CITY OF SHERWOOD
August 4, 2026
STAFF REPORT

Barkers Cabinets Phase II
Major Modification
LU 2026-003 MM

PROPOSAL: An application for a Type IV – Major Modification to an Approved Site Plan to develop an industrial structure intended for distribution and warehousing, provided product(s) are stored within an enclosed building, approximately 27,820 square feet in size. The site is currently developed with an existing industrial building, approved under LU 2022-013 SP. The subject property is zoned General Industrial (GI), ±3.48 acres in size, and located at 13470 SW Galbreath Drive (Washington County Assessors Map and Tax Lot Number: 2S128B/750).

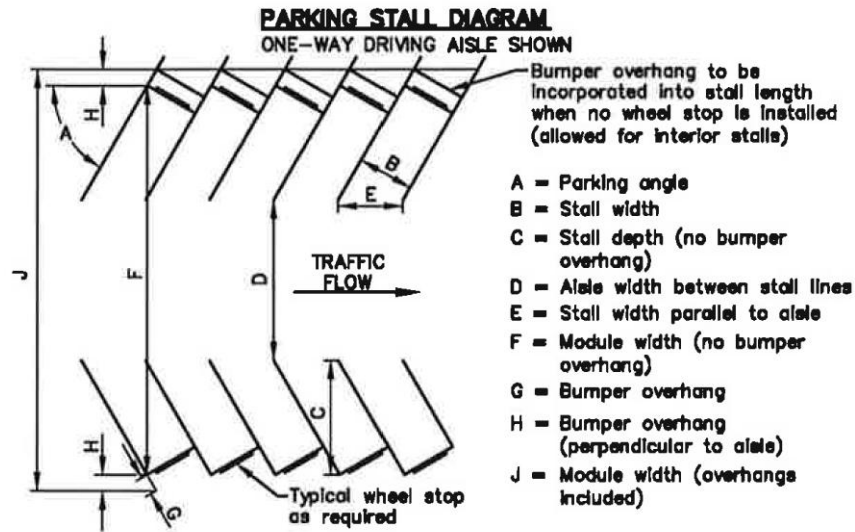
As displayed within the modified area, the applicant is proposing 35 parking stalls, below the minimum standard; No off-street parking surplus from the previous approval (LU 2022-013 SP) was available to satisfy the deficiency in parking.

As further discussed below, the applicant is seeking a reduction to the required parking, based on the criteria outlined under Section 16.94.020.B.6.
